CITY OF PORTLAND, MAINE

AGENDA PORTLAND PLANNING BOARD MEETING

Subject: Amendments to the *City of Portland Technical Manual Section 10 - Municipal Street Lighting Standards* and *Section 12 - Site Lighting Standards*

Date: Friday, March 22, 2019

Figure 5: Changes suggested by staff

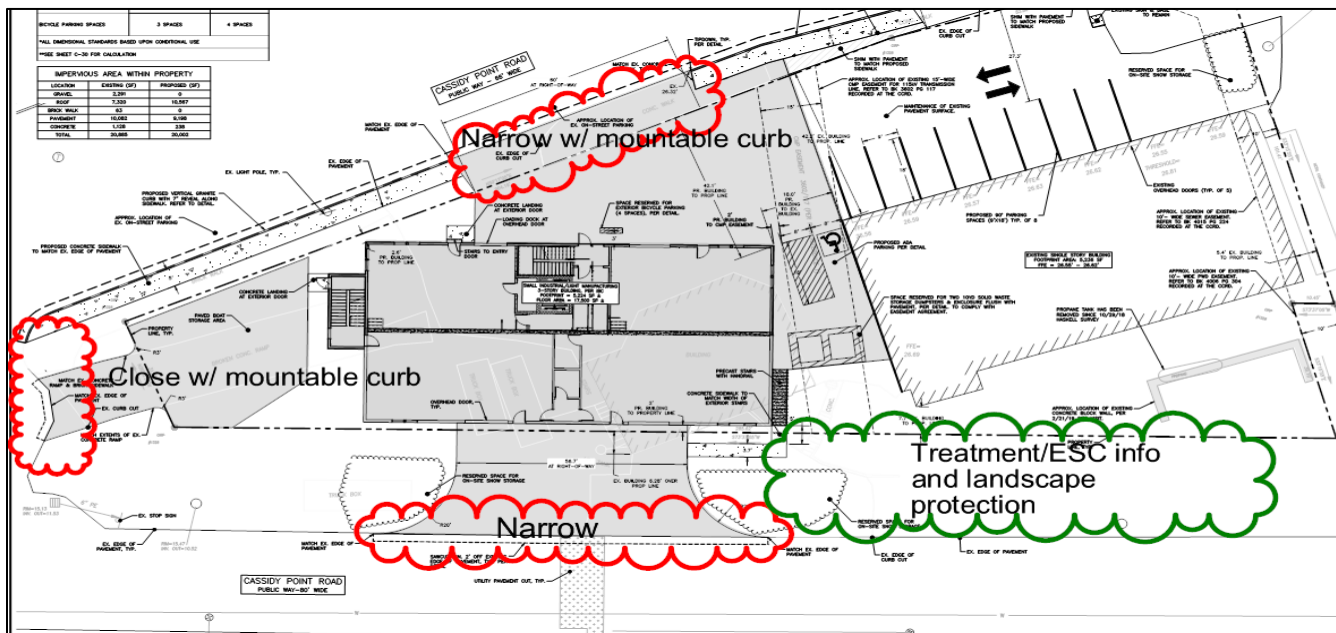
- At the acute point where the east-west portion of Cassidy Point Drive meets the northeast-southwest portion of the roadway, no curb cut shall be permitted. A mountable curb may be utilized in order to facilitate boat storage on that side of the property. The area within the City ROW shall be kept clear at all times to maintain site distance; no boats or vehicles shall be stored in this area. DPW recommends that the area within the City ROW receives loam and seed, with the exception of the area where vehicles will be loading/unloading boats, which should be concrete, porous pavers, or another structural material.
